ADDENDUM NO. 01

RE: Public Safety Training Center
SCO Project # 24-27879-01A

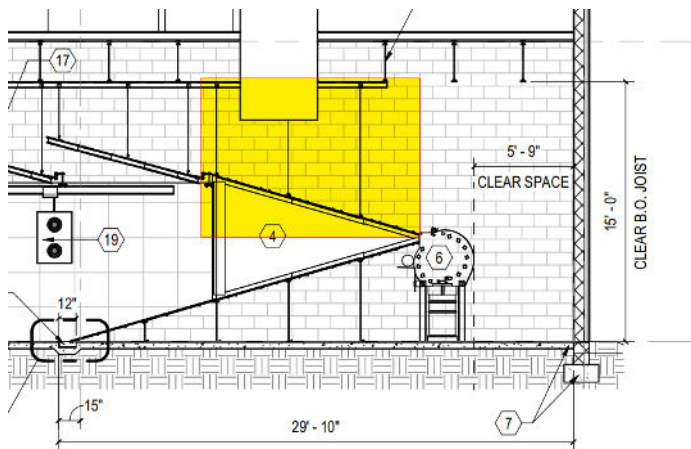
24. The lighting plan on sheet E101 shows fixtures in the range extending over the exterior wall. Based on the length of the fixtures and of the room itself, I would assume the bottom row of fixtures is not supposed to be there. Please clarify. *Response: See attached revised E-101 drawing.*

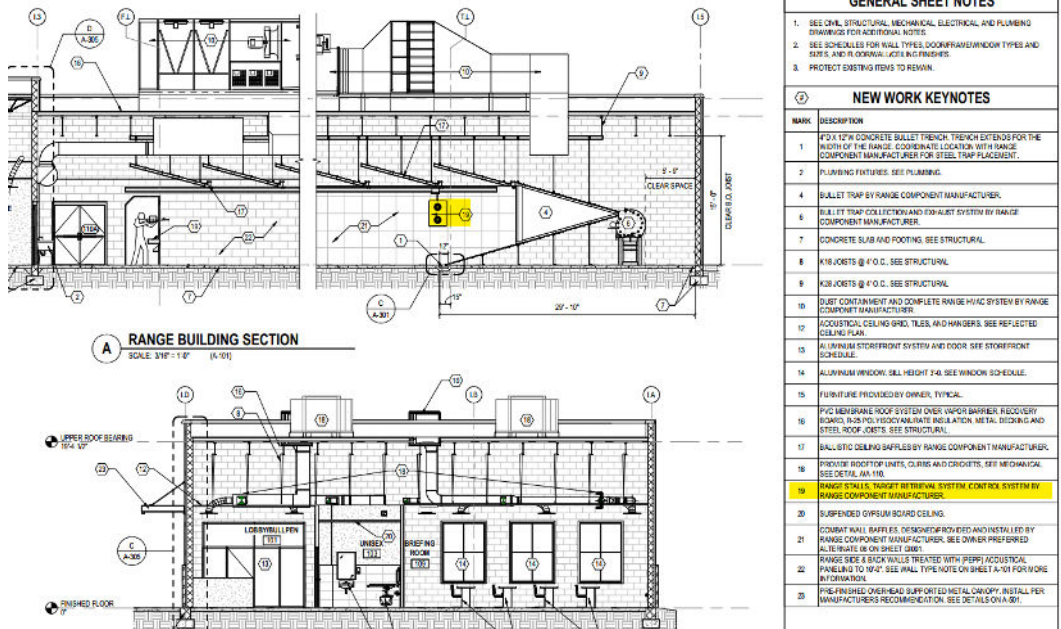
39. Question 1: 2.2.A.1.h: States: “Trap: Fully self-supported requiring no prior construction site preparation other than a flat concrete pad with prepared trench and an optional boom”. *Response: Understood- There will be overhead structure in this location.*
- The trap does require an overhead structure for the funnel plates to hang from. This spec appears to have been left in by accident. Drawing page A-301 is shown correctly, see below. The funnel plates are hung from the structure overhead.

- - It’s our recommendation for 2.2.A.1.h be omitted to avoid confusion. *Response: Section 2.2.a.1.h has been removed.*
- 40.
- 2.2.A.13: is the spec for the Dust Collection System which is a required component of the steel trap. The drawings do not indicate where the unit will be located? This unit requires power and a concrete pad that would not be included by the Range Vendor. I want to make sure that other trades like electrical and concrete are planning for this item. *Response: The dust collection system is now correctly shown with a concrete pad and power.*
- 41.
- 2.3.A.1: Which ballistic rating is required for the shooting stalls? It would make sense that the stalls be rifle rated to match the bullet trap and the calibers used on the range. *Response: The shooting stalls are to be rifle rated similar to bullet trap.*

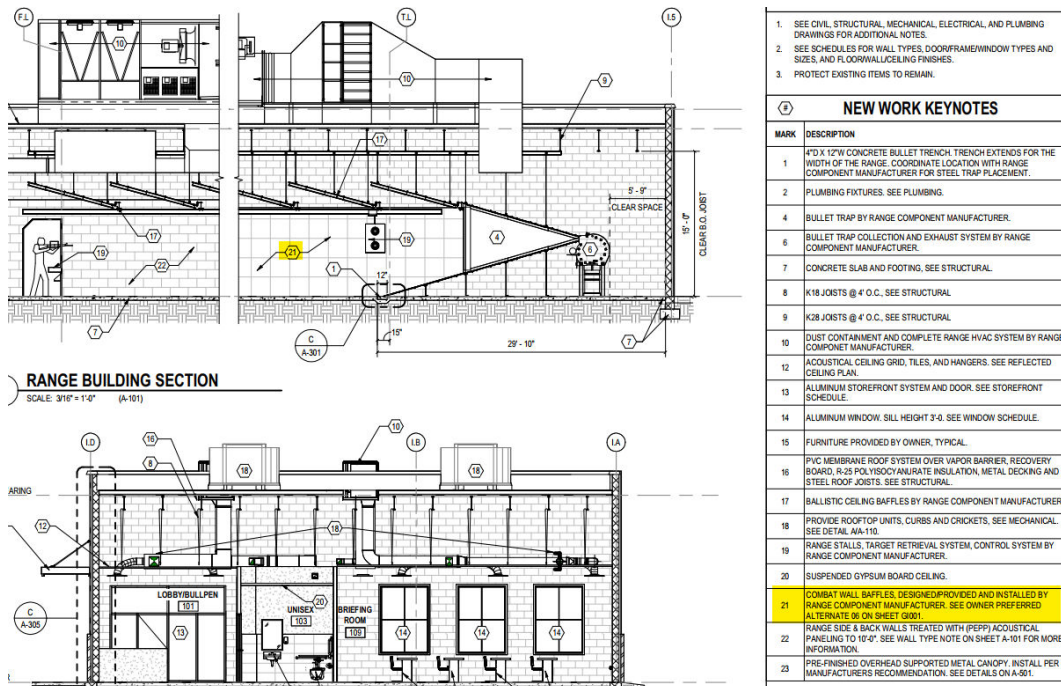
- 2.4 is a specification for a fixed turning target. The drawings, see below on page A-301, show a target retriever and previous budgets included a Target retriever. Is a different type of target the intent of the bid? If not, can the spec section be updated to the correct equipment type? *Response: The system will be a target retrieval system. The spec has been updated.*

WALL SECTION AT RANGE -
WALL BAFFLES
SCALE: 3/4" = 1'-0" (A-305)

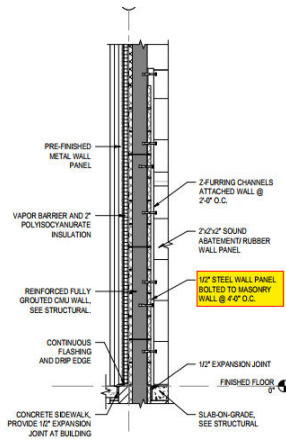
- 2.6.B is the Wall Baffle Spec. What height should the steel be from AFF? What length up range should the Wall Baffle extend to? What is the height of the rubber panels from AFF?
 - Here is page A-301 from the drawings: *Response: See updated architectural drawings for more dimensions on Wall Baffle system.*

- 2.6.B.5 requires the steel of the Wall Baffle to be 3/8" AR500 steel which is standard. Detail B on drawing page A-305 shows the steel as 1/2" which is not a standard option and would increase the cost of the project unnecessarily. Please provide clarity on which is required. *Response: The steel shall be 3/8" per specifications. See updated architectural details as well.*

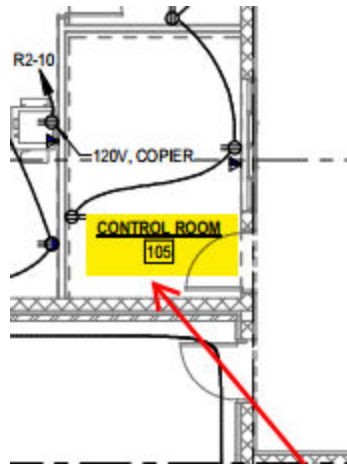
- There doesn't appear to be a spec section for any additional sound abatement on the side walls. The drawings list PEPP as the sound abatement details are in the following locations: *Response: A specification has been added for the sound abatement.*

- Wall Type Note 3 on page A-101:

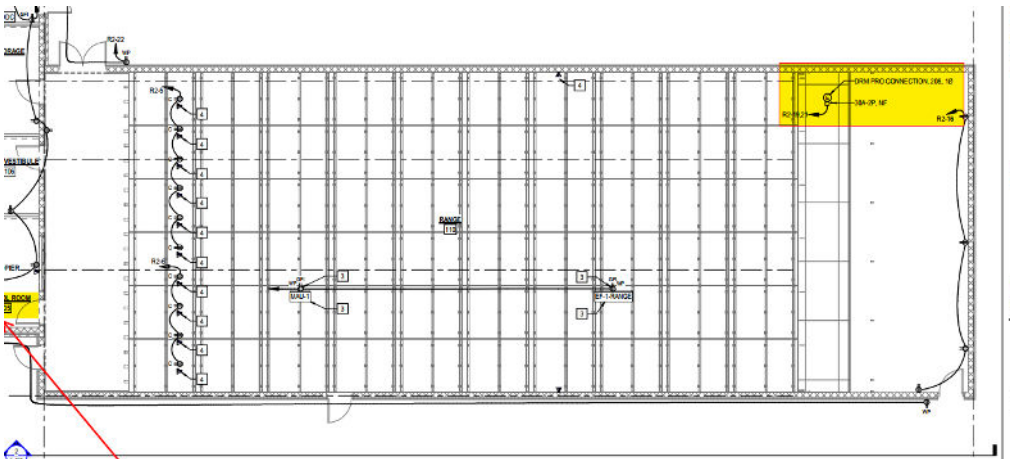
- a. Drawing page E-201 shows an electrical requirement for a DRM Pro. The specification section 11 67 23 does not call for a DRM Pro and the range section view on page A-301 doesn't show a DRM Pro. Is a DRM Pro required? If yes, can the specification be added? *Response: A specification has been added for the Running Man Target System and it is now shown on reflected ceiling plan.*
